**GEOLOGIC AND GEOTECHNICAL ASSESSMENT
RFETS BUILDING 371, ROCKY FLATS, COLORADO (U)**

**WSRC-TR-95-0482
Revision 0**

Reviewed by: L. A. Salomone
SRS Chief Geotechnical Engineer

Figure 3
Shallow Stratigraphy Under Building 371

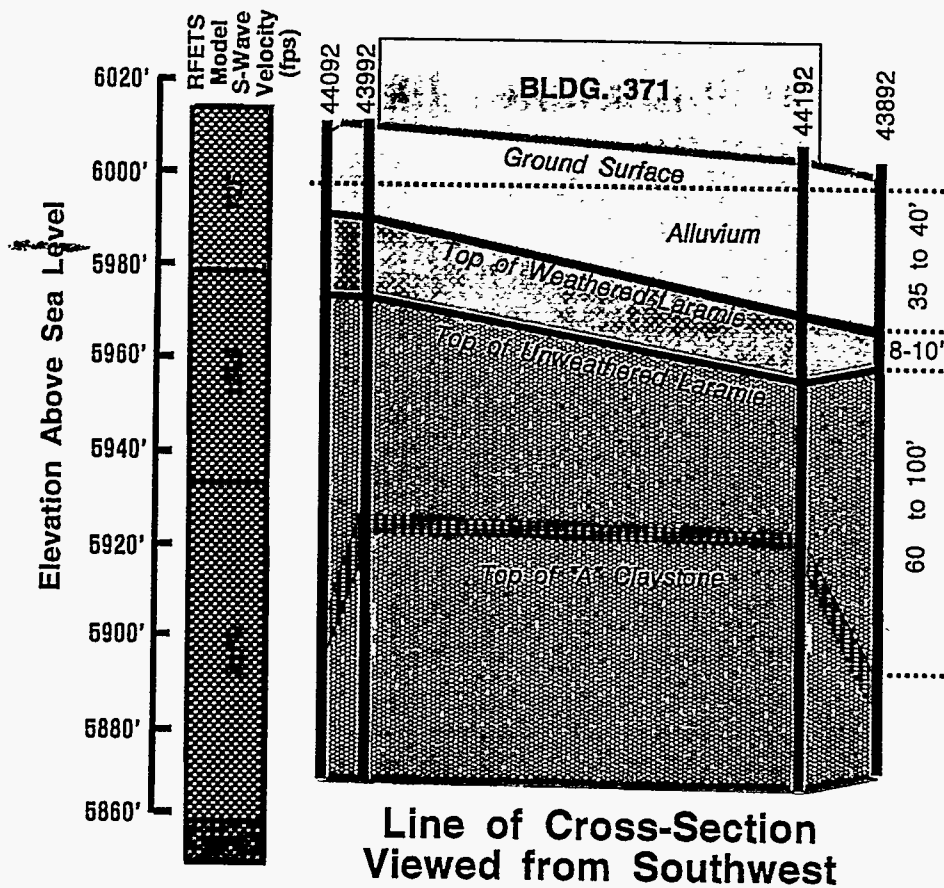
Figure 3 shows the probable impact of the regional dip on the varying thicknesses of the alluvium (although local effects cannot be precluded) but also shows the structural offset character of the "A" claystone (borings 43992 and 44192 are 'up' by 30 feet relative to borings 43892 and 44092). Based on regional dip considerations, the presence of faulting throughout the RFETS, the presence of numerous fractures and slickensides in the core descriptions, and the regional geological setting of the RFETS, the large vertical offset between borings 43792 and 44192 strongly suggest that inferred Fault #2 (from the March 1995 Geological Characterization Report) exists. Trenching studies through the Rock Flats alluvium north of Building 371, and along the presumed strike of Fault #2, found no offset in the base of the alluvium (Geomatrix, 1995).

Figure 4
WSRC Hole J Interval Velocity Plot

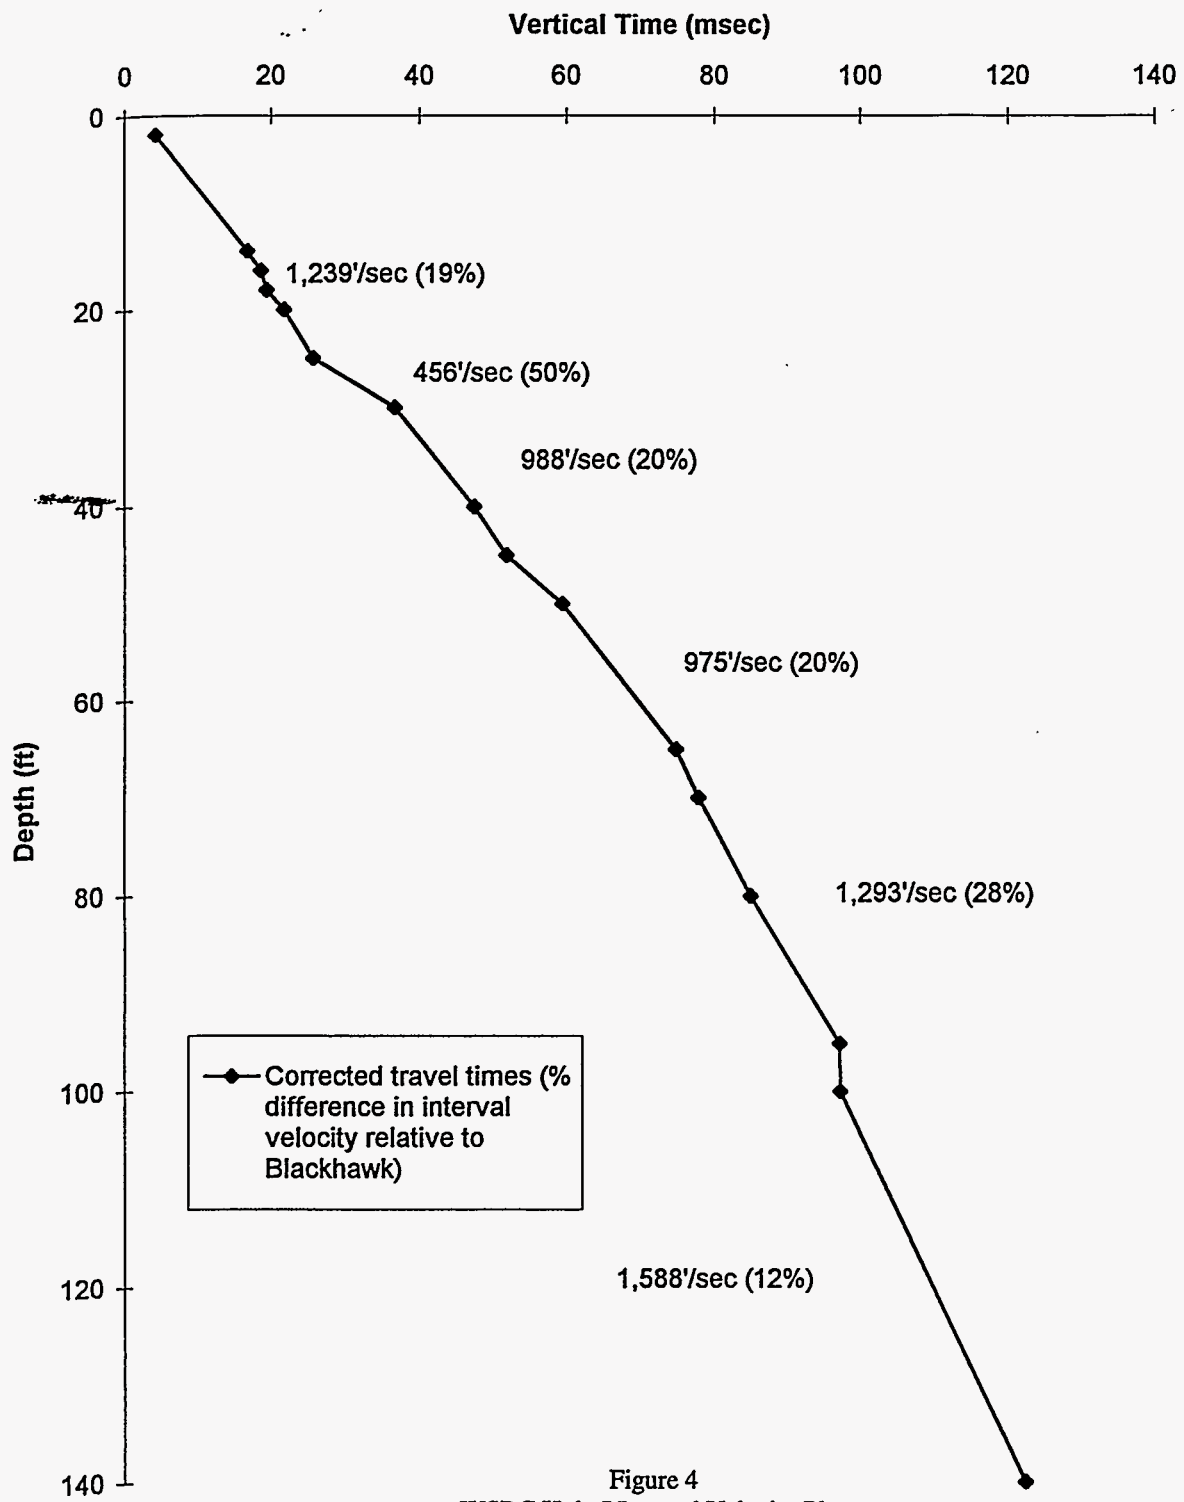
reinterpretation has somewhat poorer resolution (Figure 4) than the Blackhawk results. Interval velocities estimated from the travel-times range from about 450 fps to about 1600 fps. The average interval velocities are within 12 - 50% of the Blackhawk J-borehole velocities (Figure 4).

Figure 5
WSRC Hole L Interval Velocity Plot

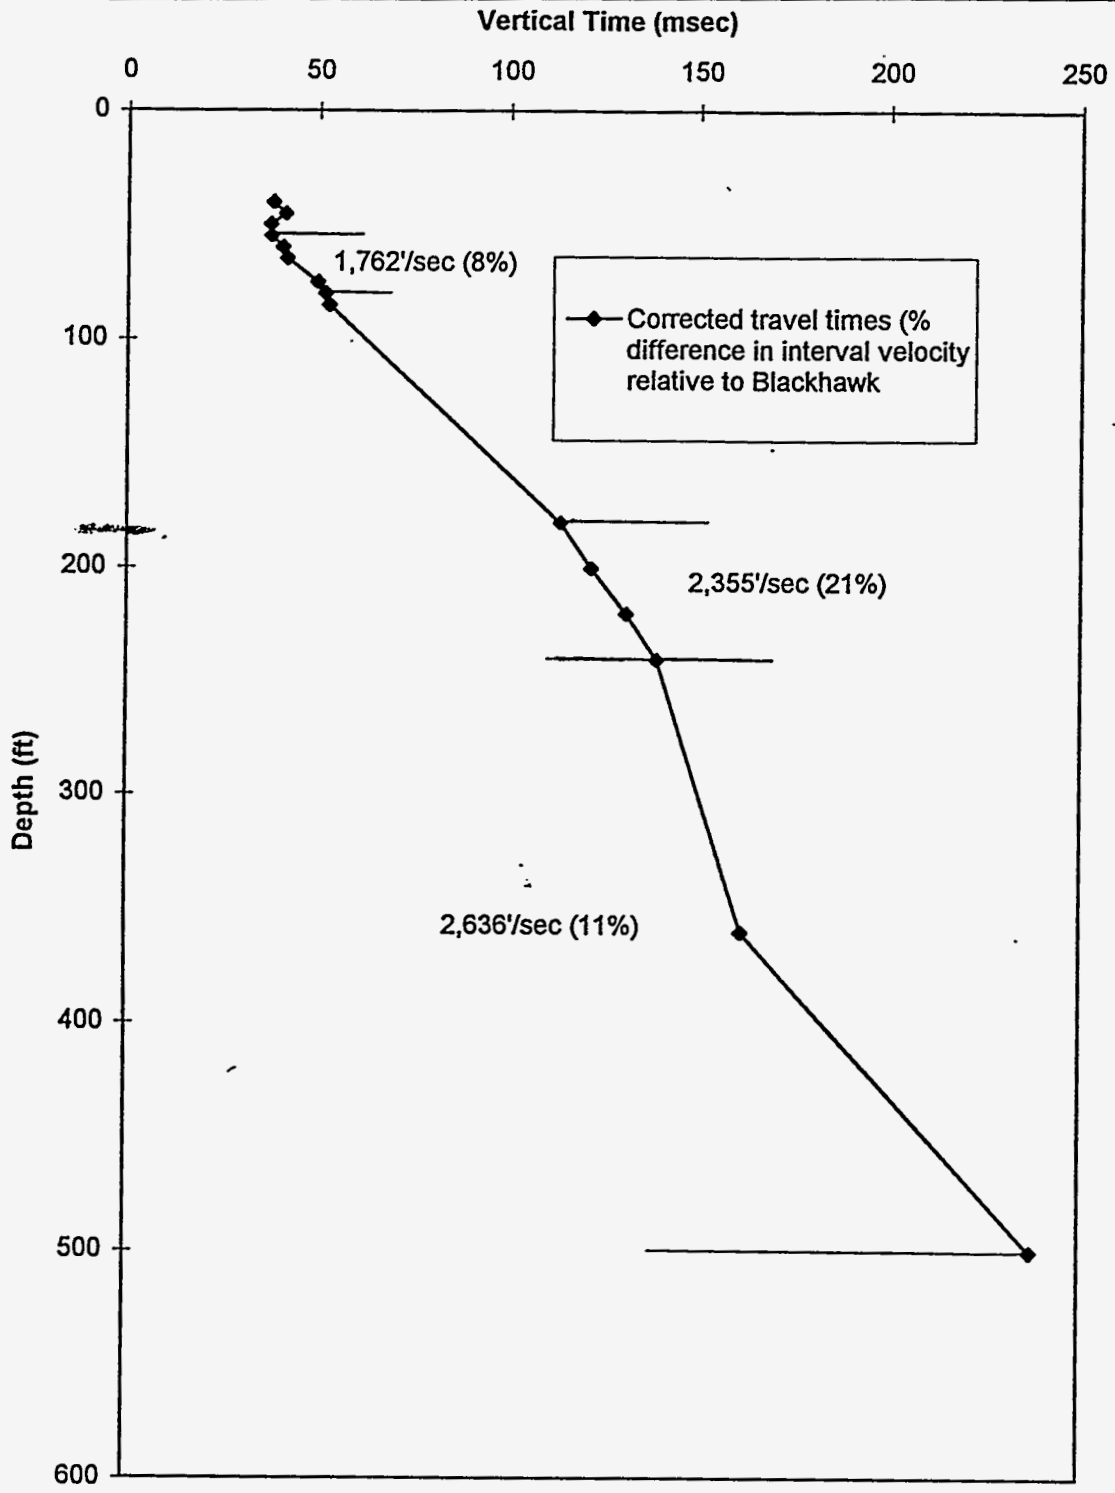
Because of difficulty in finding the S-wave arrival in many portions of the L-borehole record sections, only fifteen S-wave picks could be made in the 40 - 500 ft depth interval (Blackhawk made over twenty-two S-wave picks in each direction). The WSRC L-borehole reinterpretation has poor resolution (Figure 5). No S-wave arrivals could be picked with high degree of confidence in the depth range of about 80 - 180 ft. If the 180 - 240 ft travel-time picks are valid, then 2,000 fps speeds are expected between depths of about 80 ft and 180 ft. As mentioned above, this depth is critical to the site response and should be resolved. Below 240 ft, only two arrivals could be selected (at about 360 and 500 ft). These two "picks" are widely spaced in depth, making them very questionable because the S-wave form cannot be followed down the section. Where interval velocities could be inferred, the results are within 8 - 21% of Blackhawk L-borehole interpreted values (Figure 5). The Blackhawk interpretation for the L-borehole VSP could not be validated.

Figure 8
Blackhawk Hole-J Ascending P- & S-Wave Data Versus Averaged P-Wave Curve

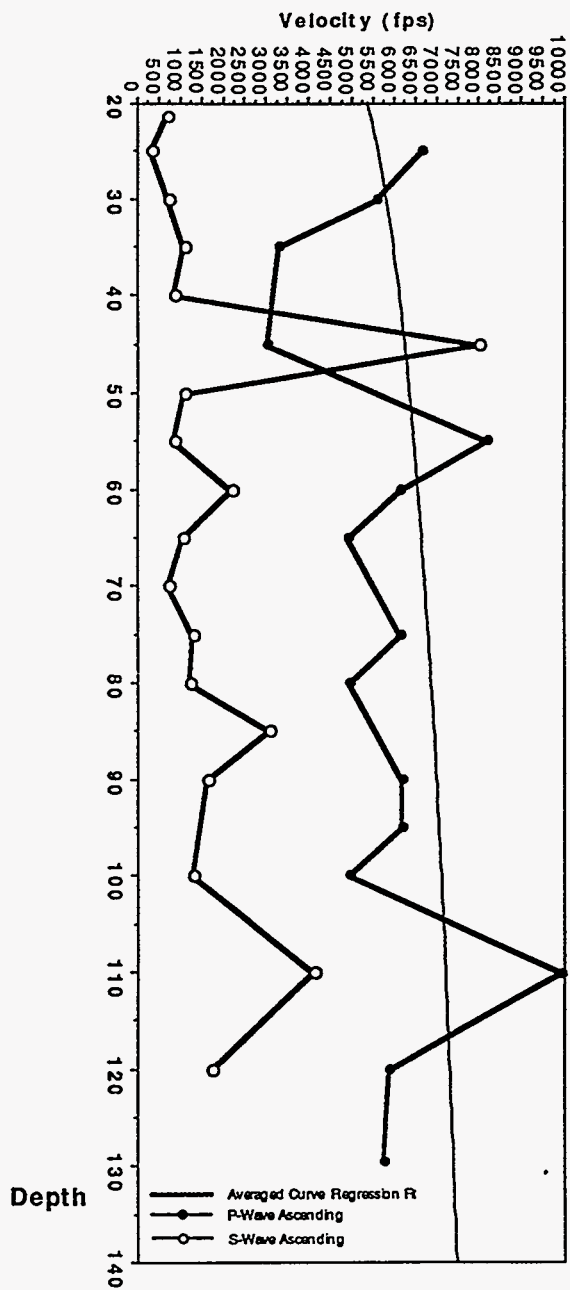
Figures 8 and 18 compares the averaged curve from boreholes 44092, 43992 and 44192 with the P-wave curves determined from the Blackhawk data for Hole J (boring 1293, nearest Building 371) in ascending and descending mode, respectively. It is apparent from these graphs that many of the Blackhawk ascending and descending results do not correlate, nor correlate with the averaged curve. In only two cases, 35 feet and 110 feet, do the Blackhawk ascending and descending results agree, and in only seven measurements do the results fall within approximate proximity to the averaged curve. As compared to the averaged curve only 9 of the 20 total measurements are potentially significant. The log normal linear regression curve for the velocity values for the Blackhawk ascending data consistently vary between 800 to 1000 fps as compared to the averaged curve. The averaged Blackhawk descending data show velocity inversion with values at the surface approximately 1000 fps faster than values at depth. Reviewing Figures 8 & 18 suggests that the ascending and descending Blackhawk survey S-wave velocities from Hole J vary by 500 to 700 fps with some disagreements as large as 2500 fps. Differences in ascending and descending values may be explained by a differing orientation of the receiving shuttle or by an inadequate clamping of the receiver to the boring wall. The reasons for the differences in velocities between the Blackhawk data and the geophysical log data are probably caused by the difference in acquisition technique. The Blackhawk data were acquired over a larger volume of lithology which averages inherent subsurface velocity differences. Because of this, it is difficult to determine where, within the volume of lithology evaluated, velocity contrasts occur. Additionally, Blackhawk data were

Figure 9
G/GMax Curves Used by RFETS (1994) after EPRI (1993)

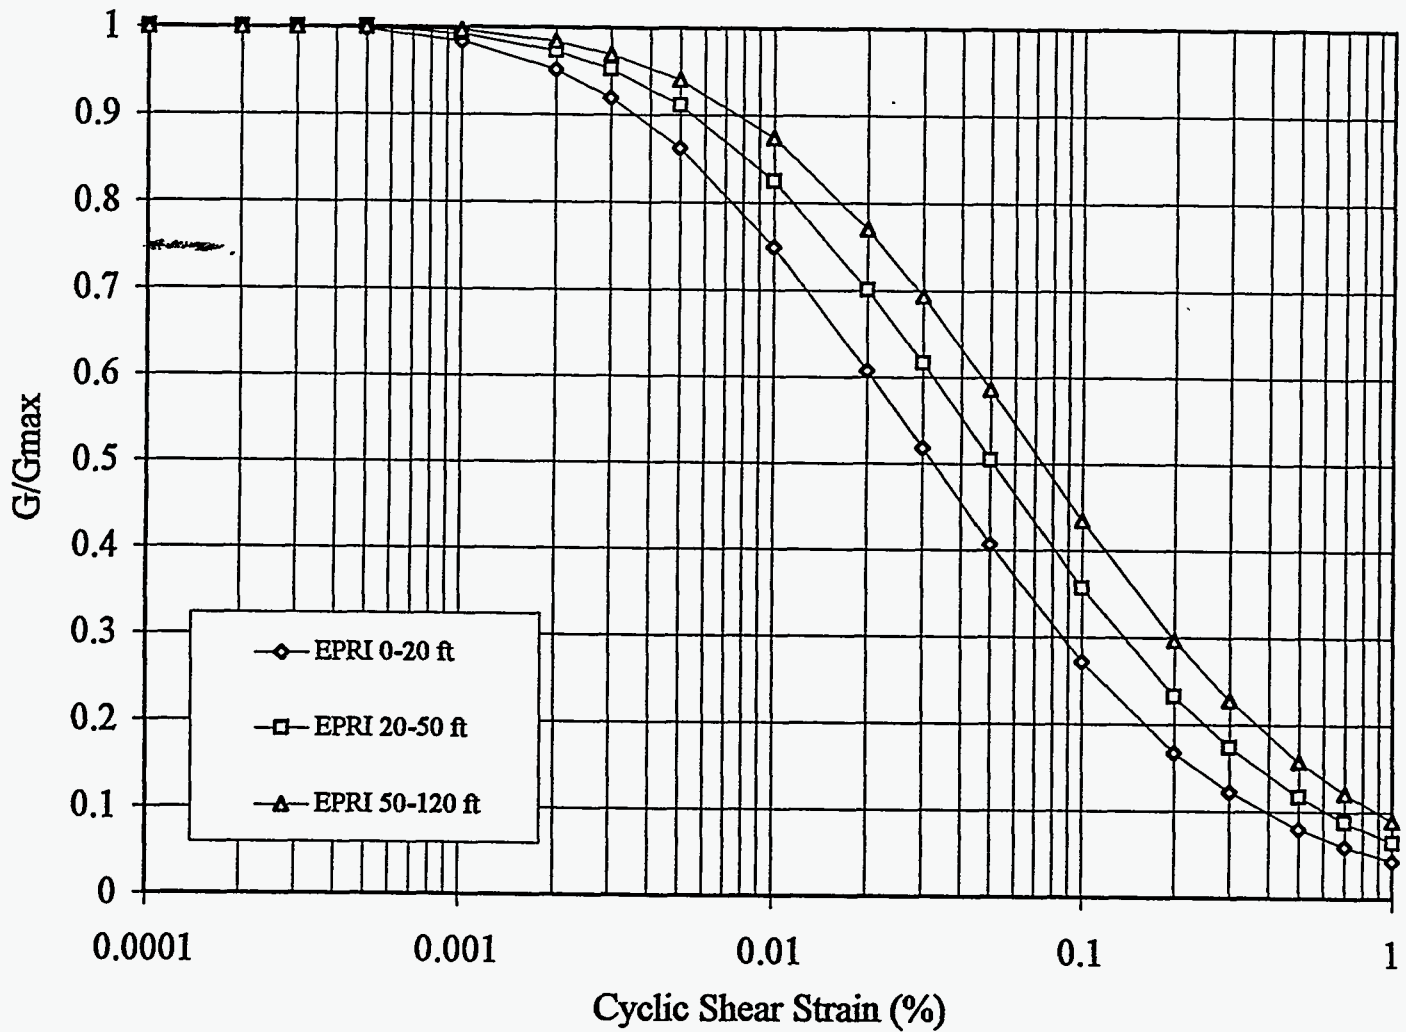
Also, no site-specific shear modulus reduction and damping curves have been developed for Building 371. Thus, the preliminary dynamic response analyses outlined in the systematic evaluation program (RFETS, 1993) used generic curves from the Electric Power Research Institute (EPRI, 1993) for both the alluvium and claystone materials. The applied curves are shown in Figures 9 and 10. These curves are applicable for generic site response studies in

Eastern North America and to soils in the range of gravelly sands to low plasticity silty or sandy clays. They should not be applied to either very gravelly or very clayey deposits (EPRI, 1993). Because RFETS is not an eastern U.S. site and the surficial alluvial soils are predominately gravels underlain by clayey soils (i.e., claystone), the applied generic curves do not appear to be appropriate for this site and would underestimate the stiffness of the claystone at higher strain values and potentially overestimate that of alluvium.
